Our Case Number: ABP-314056-22

Re: Liffey Valley to City Centre Core Bus Corridor Scheme.
Fonthill Road to High Street all in the County of Dublin.

BUSCONNECTS LIFFEY VALLEY CORE BUS CORRIDOR SCHEME

Figure 1 NTA's 'Dublin-style' junction on Ballyfermot Road

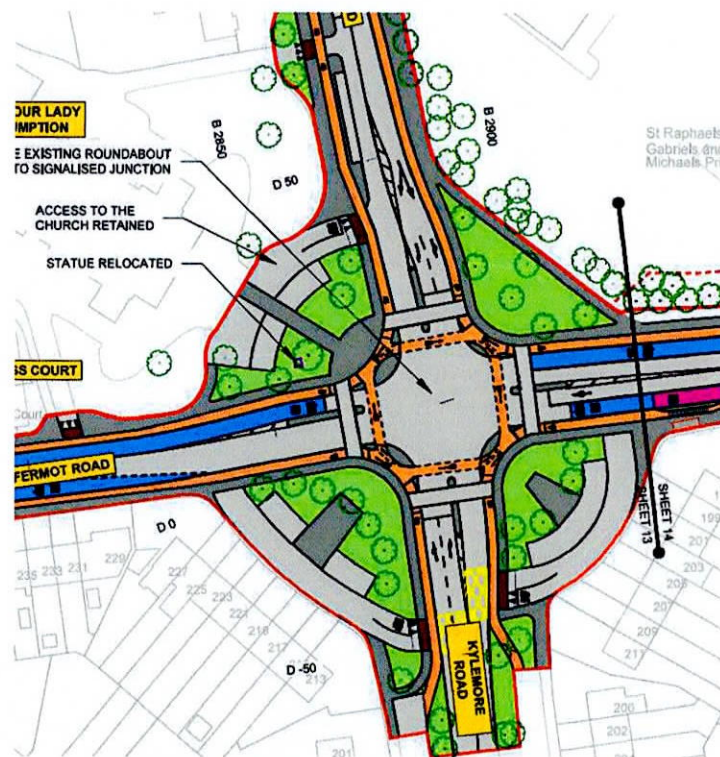
The primary junction design proposed by the National Transport Authority, the 'Dublin-style' junction (Figure 1), was designed by the NTA and does not follow international best practice in junction design.

When compared to the proven Dutch junction, the NTA's design poses a great risk of left-turning drivers crashing into cyclists and has larger crossing distances for

pedestrians. The few existing examples of this NTA design in Dublin has been widely regarded as unsafe. We request that the NTA use Dutch-style junctions (Figure 2) or CYCLOPS junctions (Figure 3) throughout the project.

Figure 4 Junction outside St. James's with one two-stage pedestrian crossing and no pedestrian crossing facilities on the other two arms of the junction

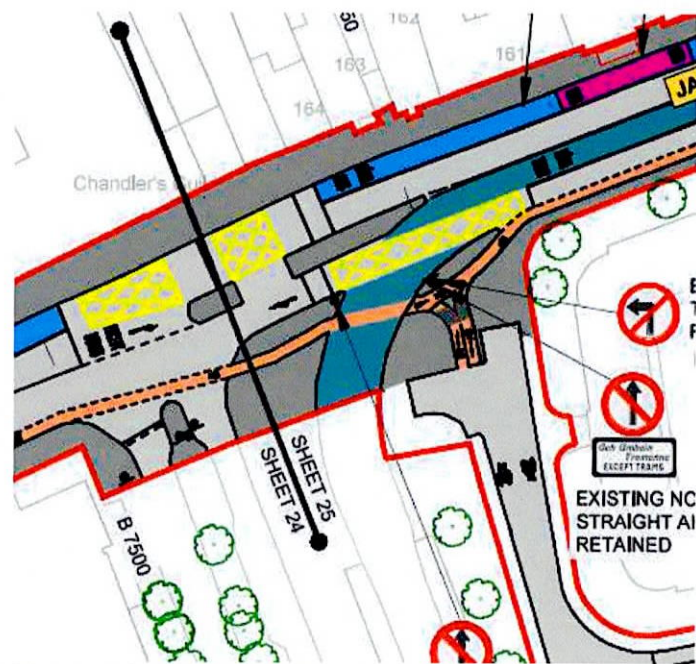
There are examples of two-stage pedestrian crossings proposed as part of this scheme. These crossings drastically increase the time required for pedestrians to navigate junctions and crossings. Section 4.4.3 Junction Design of the Design Manual for Urban Roads and Streets states that "designers should omit staggered crossings in favour of direct/single phase crossings" and Section 4.3.2 Pedestrian Crossings states that "designers should allow pedestrians to cross the street in a single, direct movement" and that "where staggered/staged crossings currently exist they should be removed as part of any major upgrade works".

The following two-stage pedestrian crossings are clearly inconsistent with the Design Manual for Urban Roads and Streets:

- Sarsfield Road/Landen Road
- James Street/St. James's

Furthermore, many three and four-way junctions are missing pedestrian crossings entirely on one or more arms. These missing crossings mean a pedestrian may need to wait for three lights — or more in the case of two-stage crossings — just to cross the street and continue their journey. Section 4.4.3 Junction Design of DMURS states that “designers should provide crossings on all arms of a junction” and Section 4.3.2 Pedestrian Crossings states “designers should provide pedestrian crossing facilities at junctions and on each arm of the junction”.

Figure 5 Bus stops with inadequate bus stop islands for cycling on James Street near Watling Street

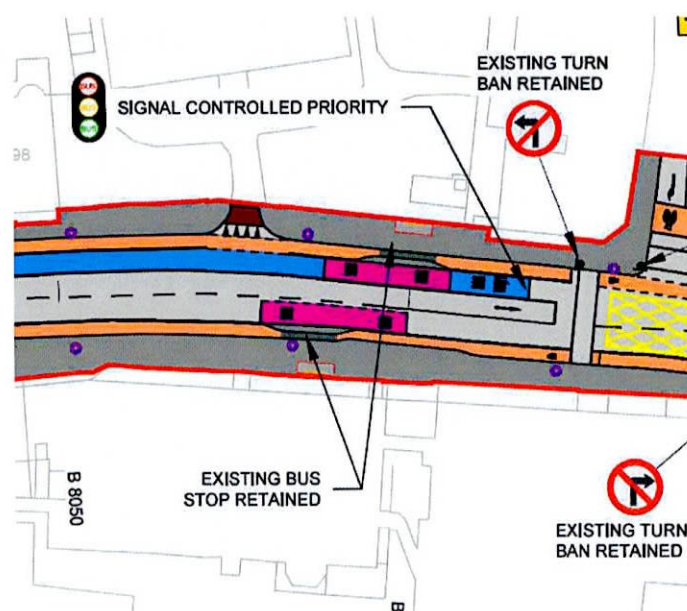
A major concern throughout the Proposed Scheme is the width of the bus stop islands that are proposed. Bus stop islands are crucial for the safety of cyclists and for encouraging all ages and abilities to use cycling infrastructure by removing conflicts

between buses and bicycles. However, narrow islands place cyclists in conflict with boarding and alighting bus passengers.

We ask that the following bus stops be redesigned to provide adequate separation between buses, pedestrians, bus passengers and cyclists for everyone's safety:

Figure 6 Proposed widening of Fonthill Road

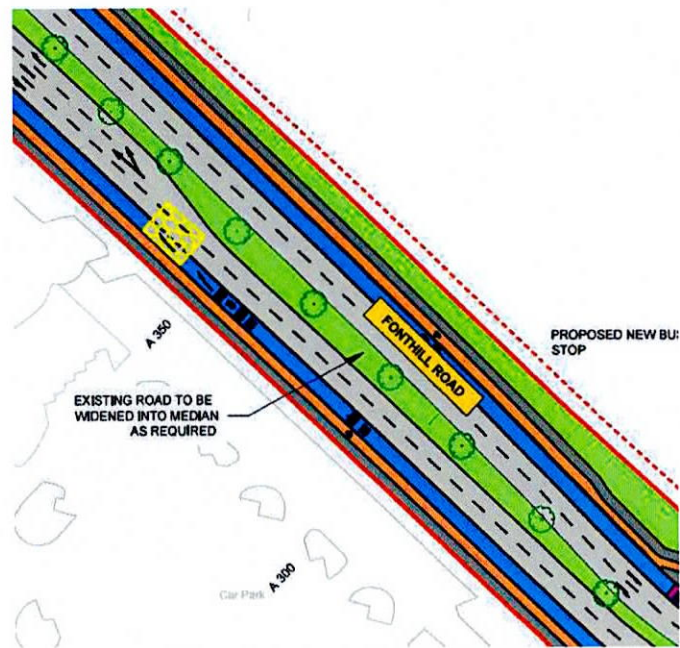
We object to the widening of the existing four lane Fonthill Road at Liffey Valley Shopping Centre to maintain two general traffic lanes in each direction. One of the existing general traffic lanes in each direction should be reallocated for the proposed bus lane to avoid unnecessary road widening.

Figure 7 Pedestrian pinch-point outside a commercial area caused by narrowing of the existing wide footpath to provide on-street car parking

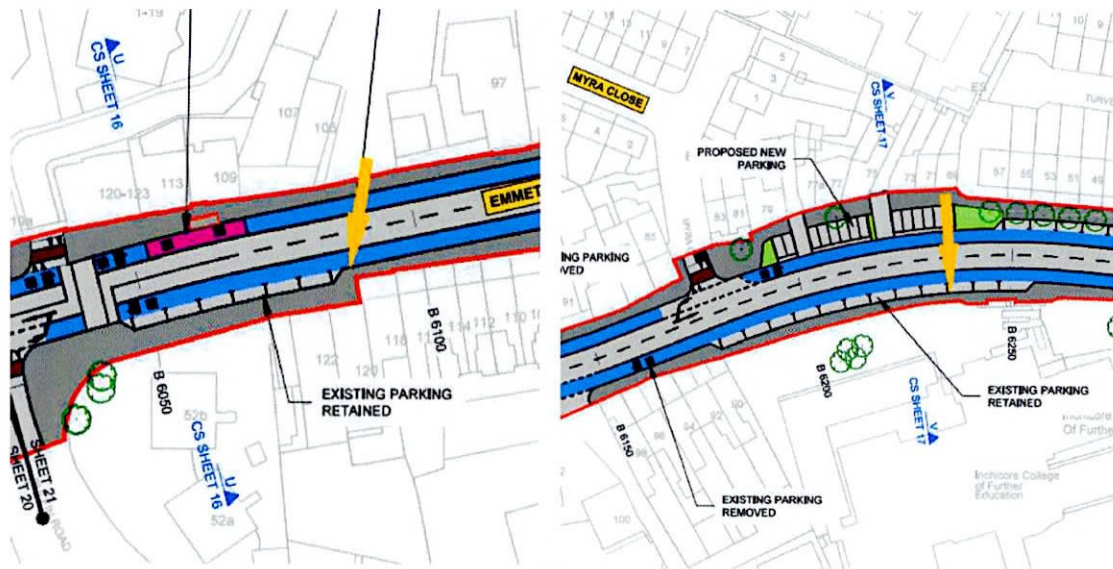
The Proposed Scheme on Emmet Road has narrow footpaths and no safe cycling infrastructure while there is provision for almost 100 on-street parking spaces. This design is entirely unsuitable for a busy commercial and residential urban road.

This focus on providing on-street car parking spaces even through compulsory purchase orders has resulted in narrow footpaths with pedestrian pinch points that do not currently exist such as outside the pedestrian entrance to Inchicore College of Further Education and outside Small Change. This prioritisation of car parking spaces

above pedestrians is clearly incompatible with the DMURS requirement to consider pedestrians first when designing urban streets and it is difficult to reconcile this design with any national or local policy objectives to prioritise walking.

We propose that, at a minimum, the Proposed Scheme omit 5 parking spaces outside the pedestrian entrance to Inchicore College of Further Education and 3 parking spaces outside the commercial area between Small Changes and Flowerpop.
